PLANNING, ZONING, & BUILDING DEPARTMENT
PZ&B Staff Combination Memorandum: Architectural Commission and Town Council

SUBJECT: ARC-24-035 (ZON-24-043) 620 N LAKE WAY (COMBO)

MEETING: JULY 24, 2024 ARCOM
AUGUST 12, 2024 TC

PROPOSED EAST ELEVATION

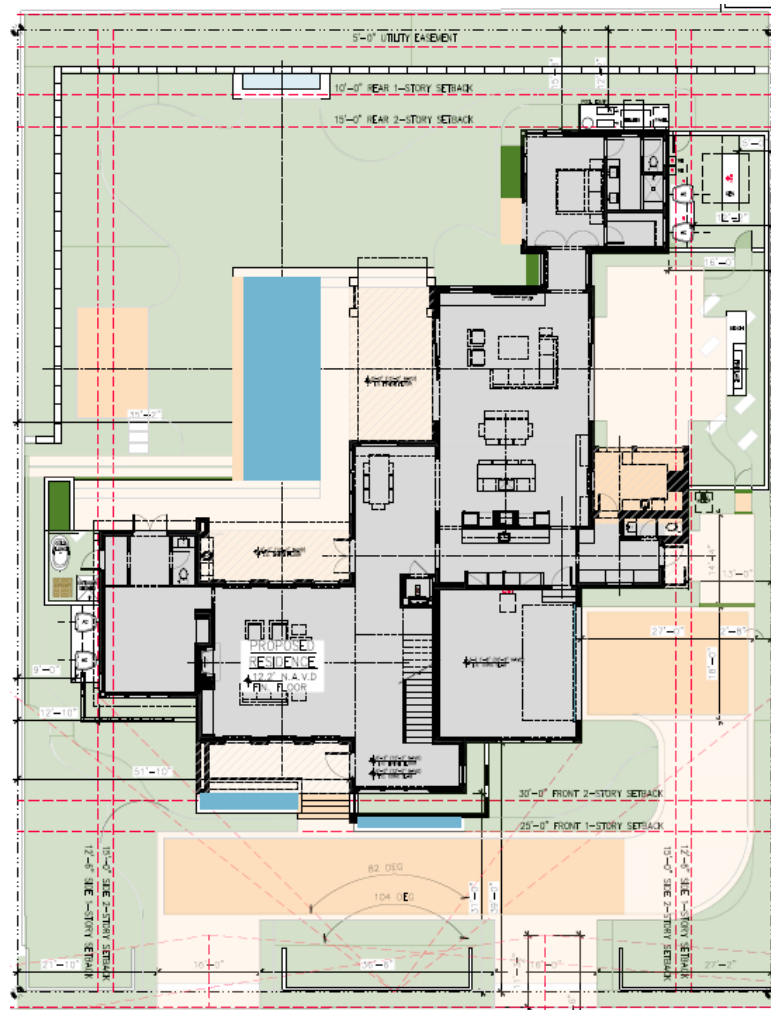
The applicant has resubmitted plans in response to commission comments received at the June ARCOM hearing. The applicant has responded by updating the design of the breezeblock and screening features, reincorporating the vertical window muntin pattern, revising the window and door frame color to a lighter color, and by adding hedge and tree plantings at the front of the property to buffer between the structure and the right of way. The overall building layout, hardscape and landscape configuration remain largely the same from previous review.

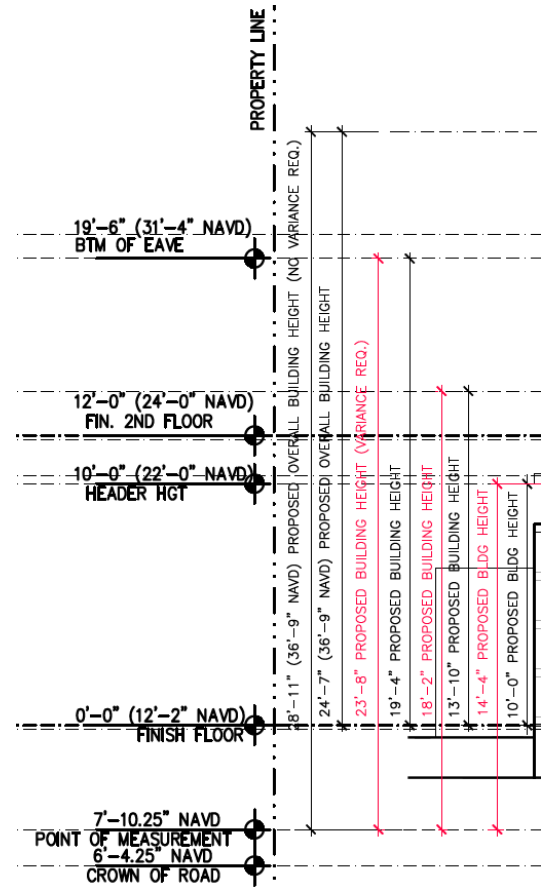
Variance 1 pertains to the proposed building height of the structure. The structure is proposed to be constructed with a building height of 23'8" where a maximum building height of 22'-0" is the maximum building height permitted. Staff will note that this is the height, as taken from the point of measurement, which is *below existing grade*. The applicant is proposing a finished floor elevation of 12.17' NAVD, and if the building height measurement was taken from this point, the building height would be 19'-4" below the 22'-0" maximum permitted.

The definition of building height clearly establishes the point of measurement at 18" above the crown of road, which does not take into account this type of parcel which experiences a somewhat significant change in grade as it traverses from the street on the east side of the parcel to the rear of the lot on the west side of the parcel. The difference in grade from the highest and lowest points on the lot are approximately 7.5'.
